SERVICE BULLETIN # 1094

MODEL 1-80, 1-60 DATE 2/4/60

SUBJECT NEW GEARCASE GASKET

NEW 51635A GASKET

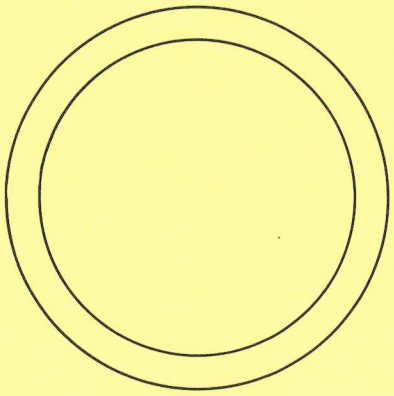
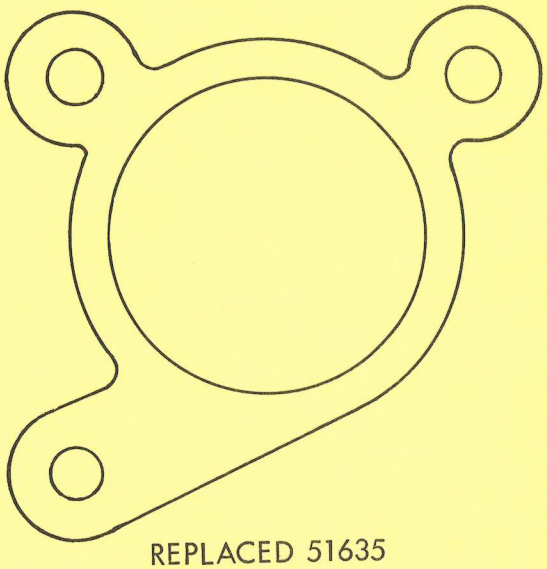
To prevent loosening of the transmission assemblies on Model 1-80 and 1-60 engines due to gasket shrinkage, a new, thin Gearcase Gasket, P/N 51635A, is available for service replacement. The new gasket replaces the thicker 51635 gasket.

The modified design of the new gasket permits metal-to-metal contact at the three bolt locations on the gearcase. It's thickness, .004 inch, is not sufficient to cause a dangerous stress across the mounting area when the bolts are tightened. The new gasket is of high rag content paper which provides an excellent seal and good compressive strength.
